File No.: DRV18-00317

Subject: 312 CENTRAL WAY MIXED USE PROJECT  
DESIGN RESPONSE CONFERENCE

**312 Central Way**  
Design Response Package  
Date: May 11, 2018  
DRB File #: DRV18-00317

**SOLAR STUDIES**

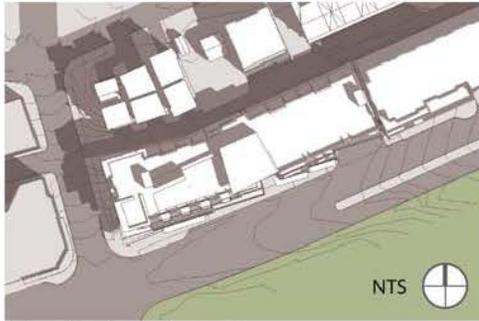
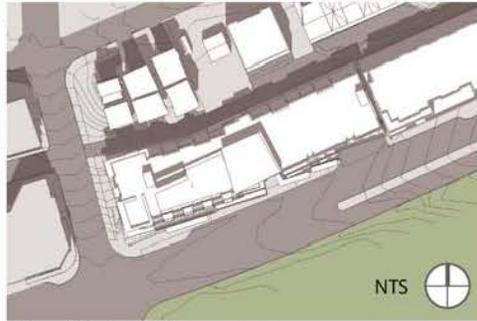
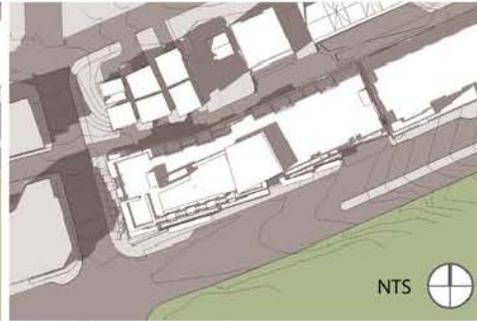
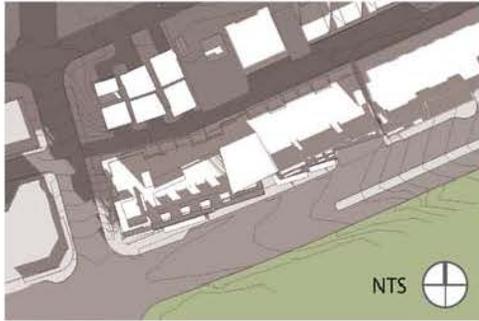
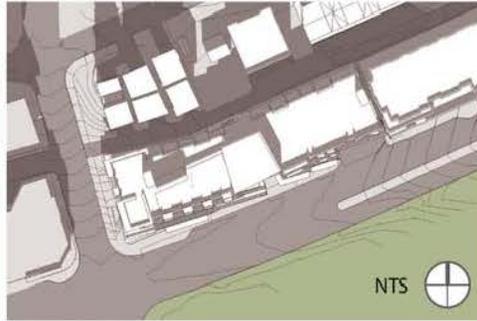
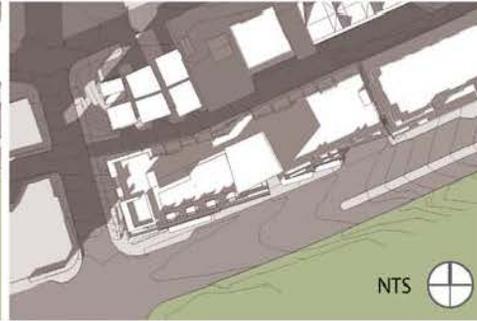
Provide solar studies to illustrate shadow impact on adjacent properties.

**3rd STREET GROUND LEVEL RETAIL FACADE**

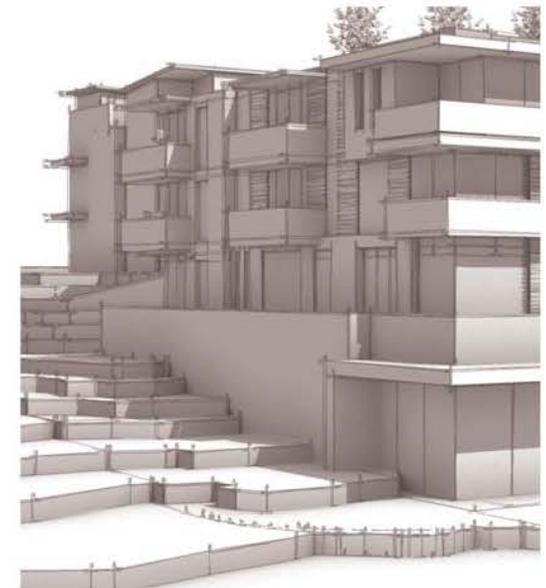
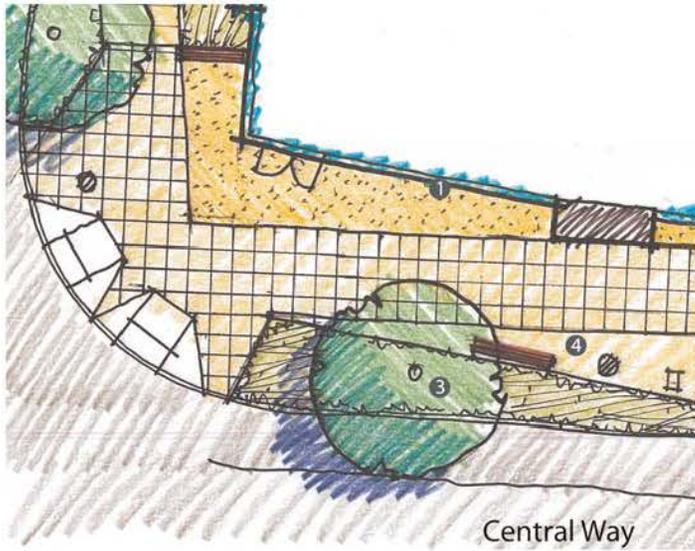
Address the treatment of 3rd Street "Blank Wall" at Ground Level. Suggest Glazing, landscaping, or other like solutions.

**CORNER PLAZA**

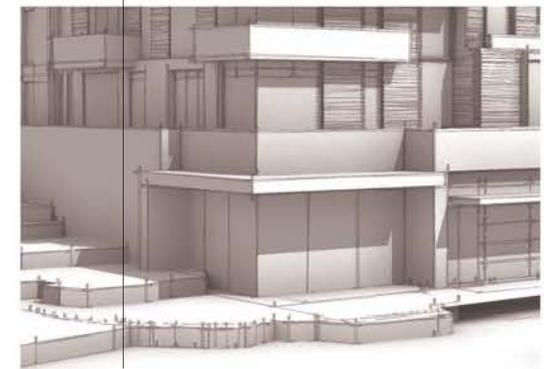
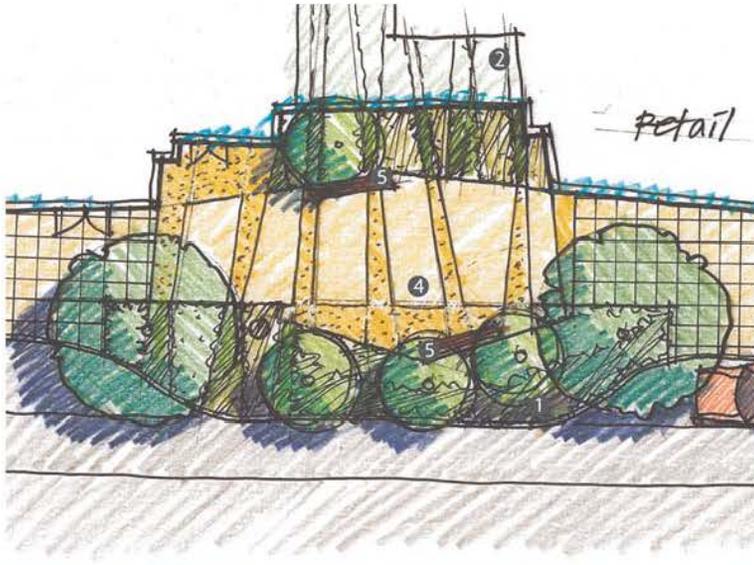
**CDC - Review Board Comments:**  
Provide detail design solutions for pedestrian plazas at entry and corner.

- Applicant Design Response:**
- ① Corner glazing set back for corner plaza
  - ② Signature architectural overhang at corner
  - ③ Landscape buffer at street edge (see Landscape section)
  - ④ Pedestrian seating within landscape buffer
  - ⑤ Existing traffic signal command box. Project proposing to move.

**ENTRY PLAZA**

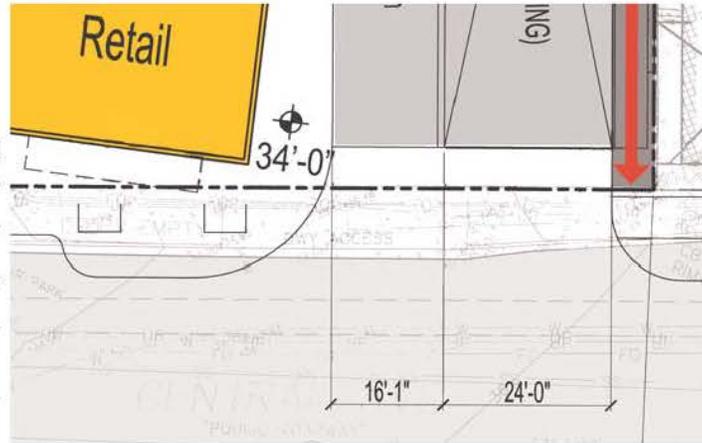
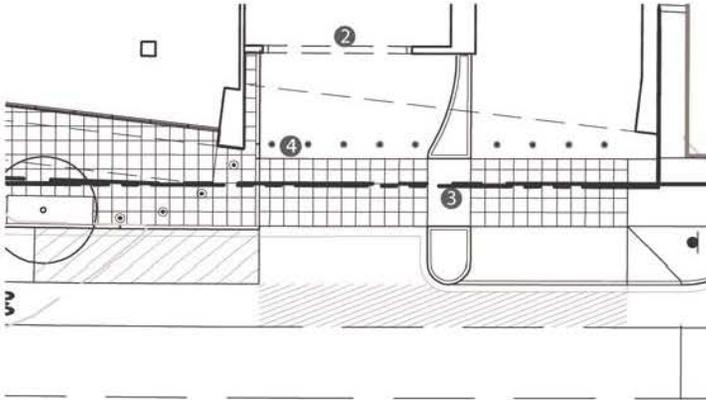
Provide detail design solutions for pedestrian plazas at entry and corner.

- ① Landscape buffer bulbed into street
- ② Landscape extended into lobby
- ③ Signature entry overhang
- ④ Identify entry plaza with change of hardscape
- ⑤ Pedestrian seating
- ⑥ Transparent facades at corners and central hub

**BUILDING MODULATION**

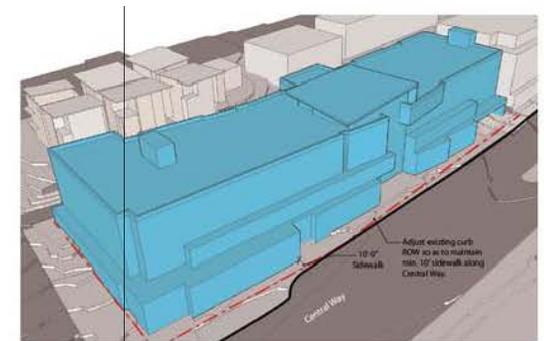
Increase modulation on both the alley and Central Way facades.

**BUILDING MODULATION**

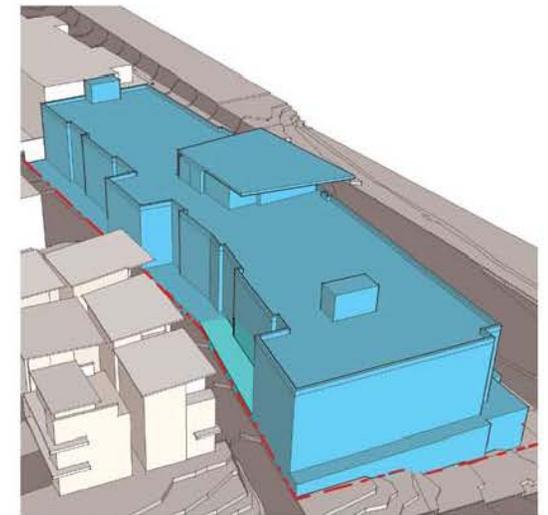
Increase modulation on both the alley and Central Way facades.

**BUILDING ROOF LINES**

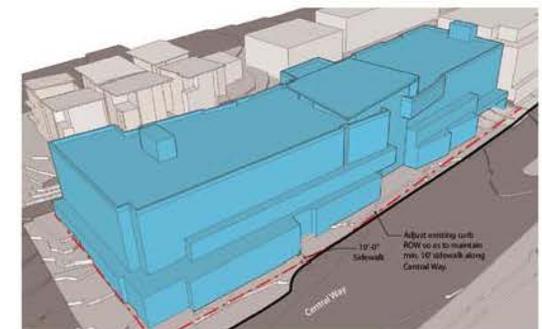
Increase the variety of roof lines and element.

- ① Two+ foot vertical variation for vertically modulated elements.
- ② Enhanced facade variations through change of material color.
- ③ Signature rooftop expression at "central hub."
- ④ Further break-down of overall roof parapets with highlighted architectural elements.

ZONING VOLUME DIAGRAM

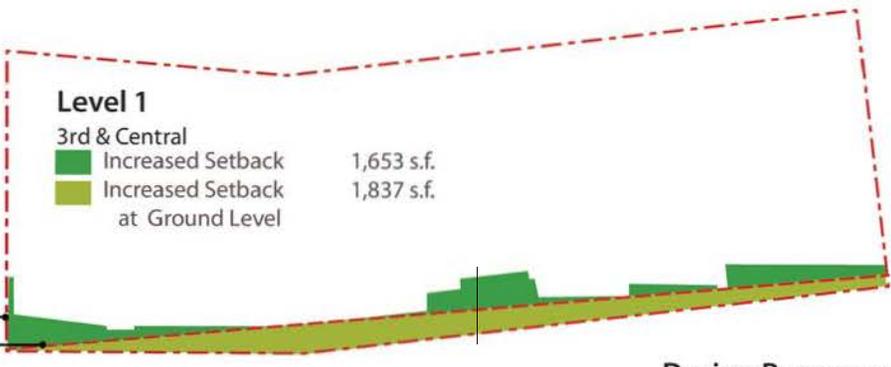
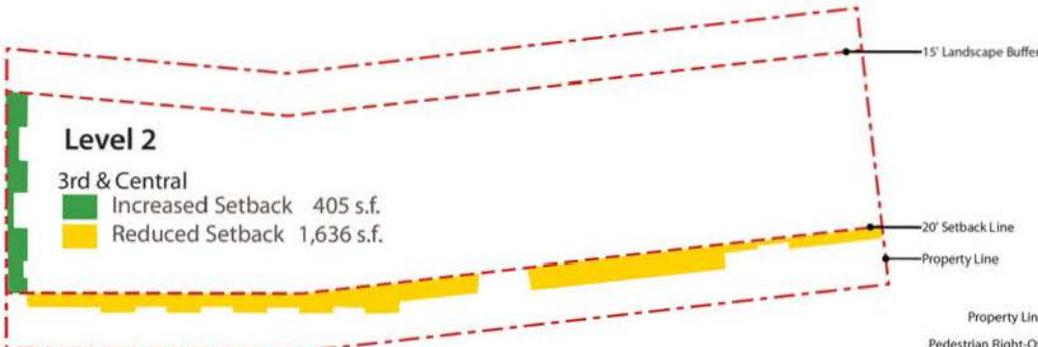
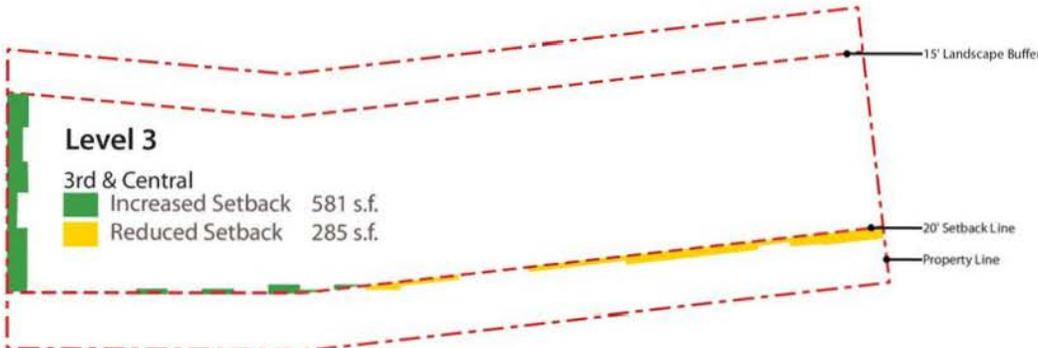
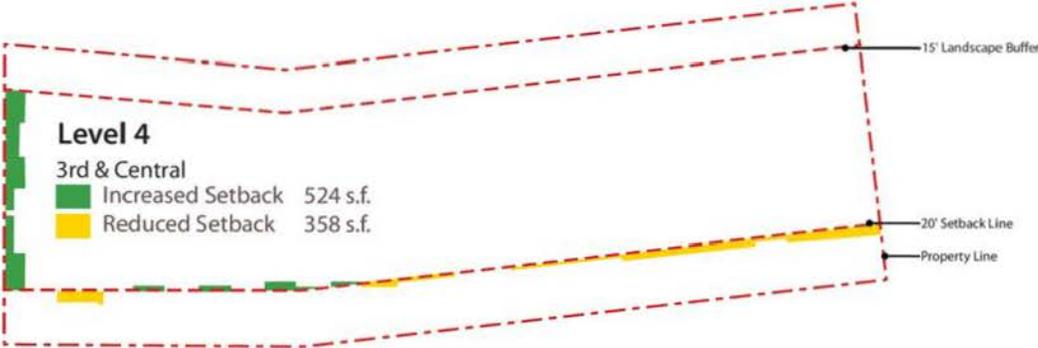
**CDC - Review Board Comments:**  
 Provide graphics and data quantifying area encroaching into zoning setbacks as referenced in KZC sec 142.37.4. Include design elements to activate building corners.  
 Communicate how design supports encroachment by providing superior design and extra city benefit.

**ROOF DESIGN**

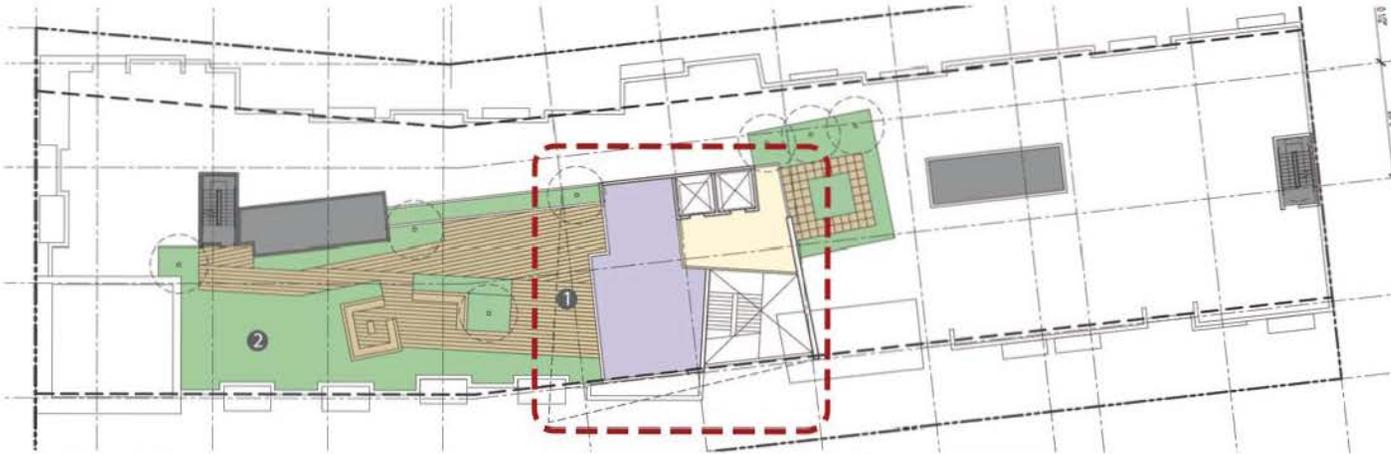
**CDC - Review Board Comments:**  
Work with staff to address allowed rooftop amenities.

- Applicant Design Response:**
- ① Atypical and enhanced roof experience. Rooftop supported by adjacent amenity.
  - ② Green roof solution provides better view experience for adjacent properties as well as other properties within viewing range.
